PUBLIC HEARING AND PLANNING COMMISSION MEETING
Thursday, February 28, 2008 7 00 p m
Public Safety Building
3925 W Cedar Hills Drive, Cedar Hills, Utah

TO: Planning Commission
FROM: David Bunker, City Engineer
DATE: February 28, 2008
SUBJECT: Amsource Final Site Plan Approval

The following represents an Amsource Cedar Hills, LLC's response to the City Council Hearing Preliminary Approval held December 12, 2007:

Cedar Hills Retail Center

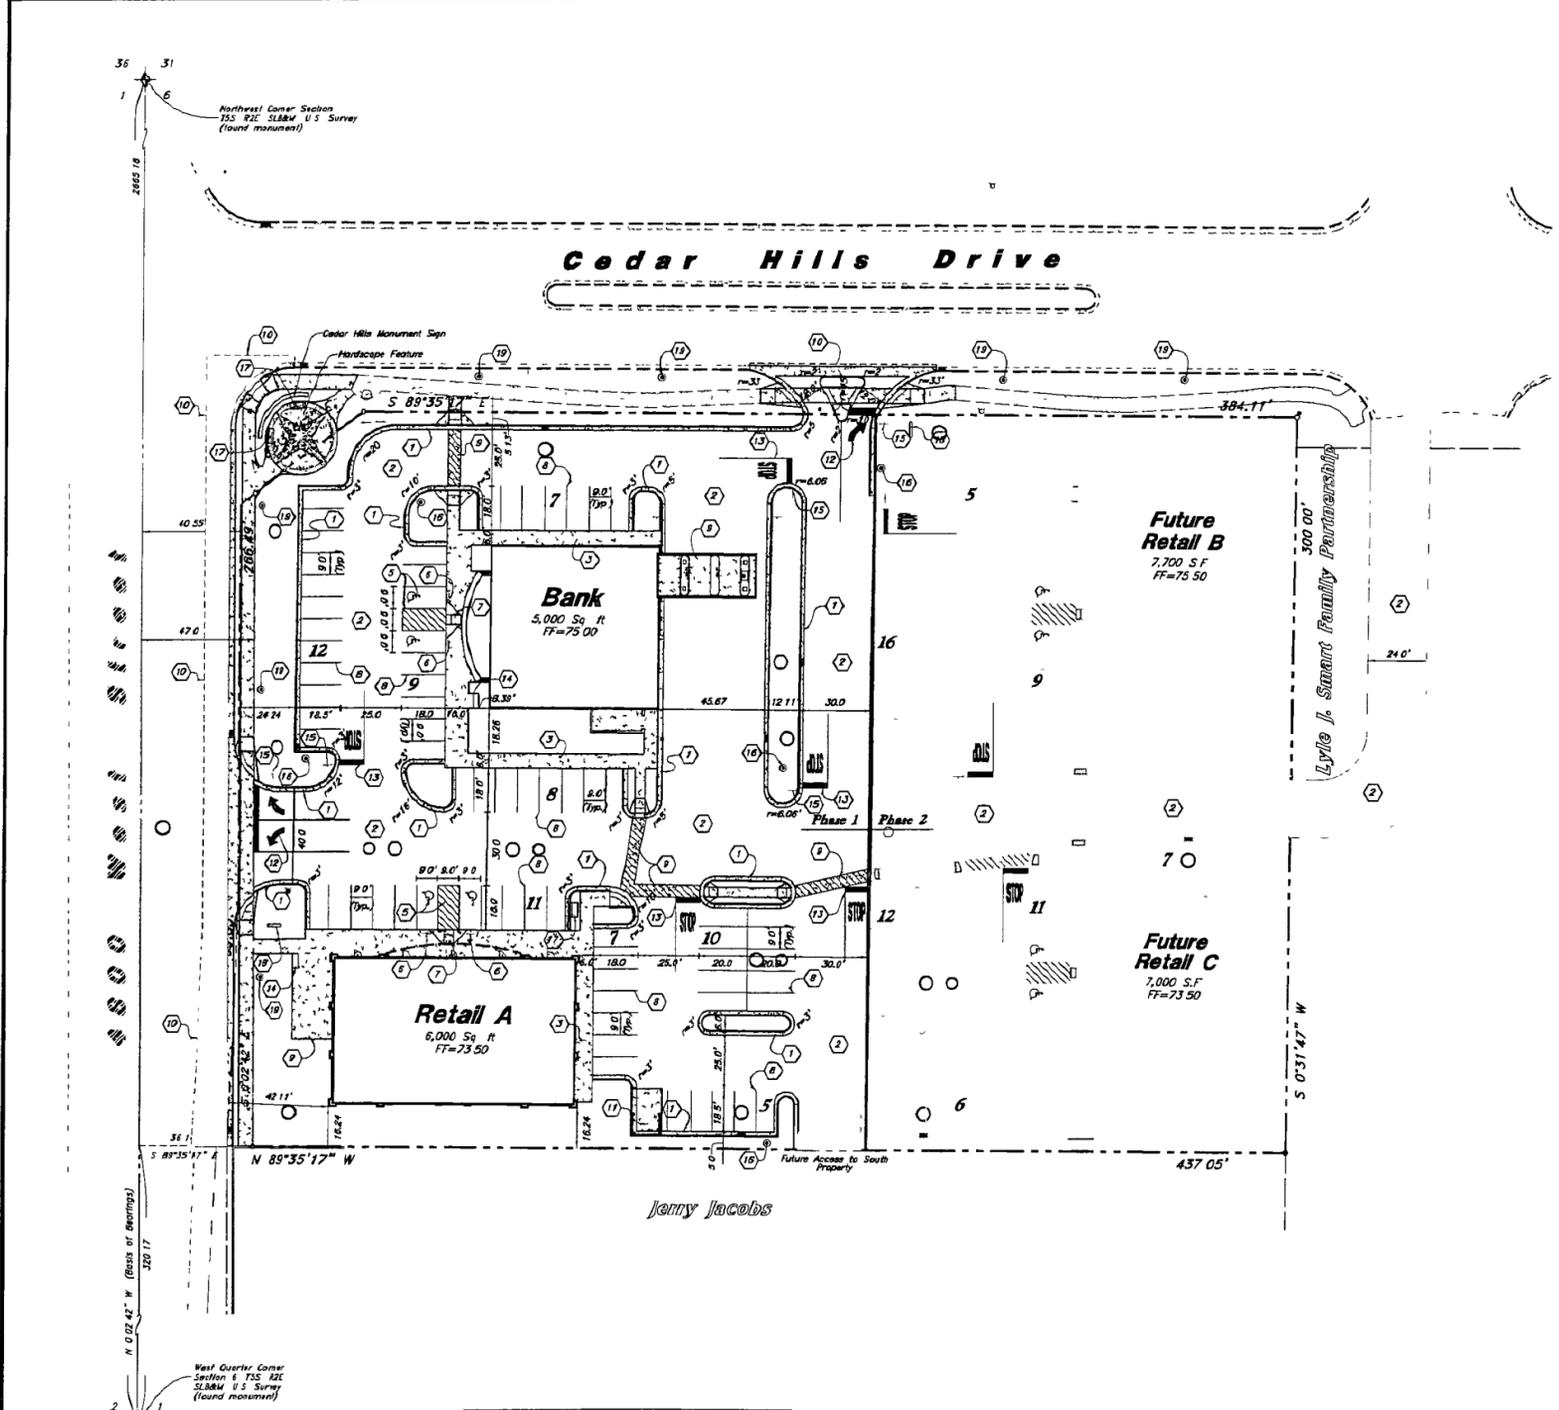
- Water valve shall be added to line on east boundary
- All lighting shall be included on one sheet in an overall lighting plan
- Lighting shall be modified to provide more lighting to ingress/egress

- Submit detailed storm drain calculations including sub-basin design. Submitted sump design does not meet City Standards and Specifications
- All sheets shall show utilities extended to east property line

- Final engineering
- Submit storm water management and erosion control plan. UPDES permit required
- Show detail of landscaping features, including bike racks, benches, stamped concrete, etc

The plan provides traffic control signs, stop bars, pedestrian cross walks indicated with colored pavement and ADA accessibility. Pedestrian corridors extend throughout the center, connect to existing sidewalks on Cedar Hills Drive and to be constructed sidewalks on 4800 West Street. Pedestrian flow paths connect the store fronts of the proposed Phase 1 buildings and the future phase building without visual obstruction. Parking areas are adjacent to landscape areas and contain landscape islands. The largest single row of parking is only 12 stalls. Dividing the site with landscaping elements and small fields of parking strategically placed provides for a human scaled and pedestrian friendly development.
